APPLICATION NO.	FILING DATE	FIRST NAMED INVENTOR	ATTORNEY DOCKET NO.	CONFIRMATION NO.
10/587,153	07/25/2006	Josef Artelsmair	ARTELSMAIR ET AL 8 PCT	4970
COLLARD &	7590 09/08/201 ROE, P.C.	1	EXAM	TINER
1077 NORTH	ERN BOULEVARD		DANG, KET D	
ROSLYN, NY	115/6		ART UNIT	PAPER NUMBER
			3742	
			MAIL DATE	DELIVERY MODE
			09/08/2011	PAPER

Office Action Summary

DETAILED ACTION

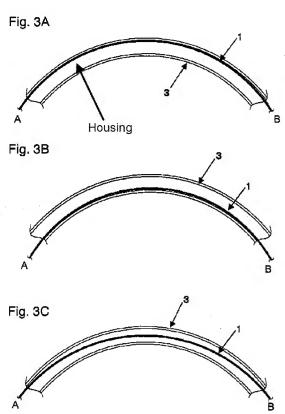
Regarding claim 6, Mukai et al. discloses a welding wire storage device for a welding system (see figure 1) comprising: a housing 3 (fig. 3A) (see figures 3A below for the indication of a housing) having a free space, a first end region 5 (fig. 1) and a second end region 6 (fig. 1) opposite the first end region (para. 0050-0051); a welding wire 1 (fig. 1) arcuately arranged to lie freely in the free space of the housing; a guide element on the second end region 6 (fig. 1) (para. 0020); and first 5 (fig. 1) and second 6 (fig. 1) coupling mechanisms arranged on the housing (para. 0020, 0021, 0046-0047).

With respect to claim 3, Mukai et al. discloses wherein elements for delimiting maximum deflection of the welding wire 1 are arranged in the housing 3 (fig. 3A) (para. 0019, 0031).

With respect to claim 5, Mukai et al. discloses wherein the housing (see fig. 3A below) is arranged between a welding apparatus or wire feeder 2 (fig. 1) and a welding torch 4 (fig. 1), wherein a hose pack 3 (fig. 1) is arranged directly, without interruption, between the welding apparatus or wire feeder and the welding torch, and wherein the wire core is interrupted in the housing 3 (fig. 3A) (para. 0012).

Mukai et al. discloses all of the limitations of the claimed invention as set forth above, except for a wire core and a wire guide hose for the wire core; and a measuring device for detecting deflection of the welding wire.
